## 106 Albert Street, London NW1 7NE - Addendum to Design & Access & Heritage Statement (Rev A)

July 2019 (Revised Dec 2023)

3rd Floor - Consented in the 2014 Application

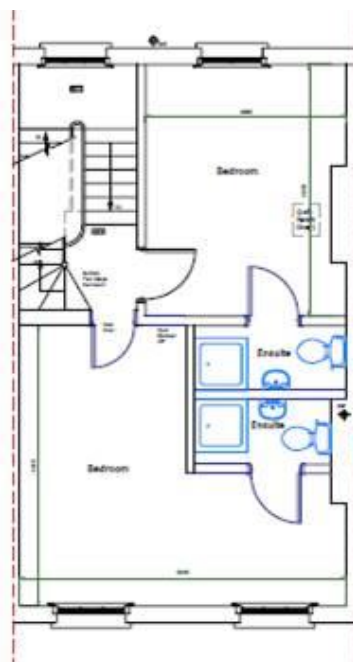
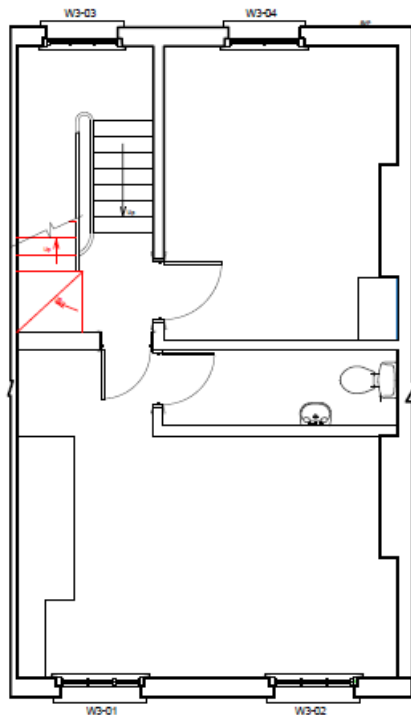
9. **3<sup>rd</sup> Floor Layout and Staircase** - Concerns raised by the conservation officer with regards to the 3<sup>rd</sup> floor layout are as follows: *‘At third floor the alterations to the plan form are not acceptable. The front room/rear room composition should be retained and any new staircase should not involve the removal of any historical internal walls. It would be helpful to have some evidence justifying a new staircase’*

*At third floor the alterations to the plan form are not acceptable. The front room/rear room composition should be retained and any new staircase should not involve the removal of any historical internal walls. It would be helpful to have some evidence justifying a new staircase. If a bathroom is necessary on this floor, one of the existing rooms should be used for this purpose or a pod like structure could be inserted.*

10. The earlier configuration of the rooms on the 3<sup>rd</sup> floor include a vestibule in the rear room, which changed the original circulation even more fundamentally than the existing layout.
11. Prior to latest works, the front room was subdivided, thereby fully altering the planform on this level. The door into the front room (bedroom 1) had also been altered to allow for the later staircase to be inserted on the landing. This wall therefore has already undergone substantial alterations.

12. The staircase as consented in 2014, was deemed to be wholly impractical and would have resulted in a dangerous, impossibly steep staircase. It also would not have allowed for a landing at the top, where the consented utility is located. The current arrangement was implemented out of necessity as the consented one did not work.
13. Having explored alternative options (see drawing below), it is concluded that due to the highly limited space on the top floor, the current staircase and the reconfiguration of the front room doorway and wall was the only way to install a buildable, practical and safe staircase. The scheme as existing removes the need for the vestibule at the rear room and the appropriate circulation with doors leading to the front and rear room off the landing is thus retained in principle.

I've spoken to my colleagues and as the top floor has been subject to a variety of alterations, I'm willing to accept the current staircase position.
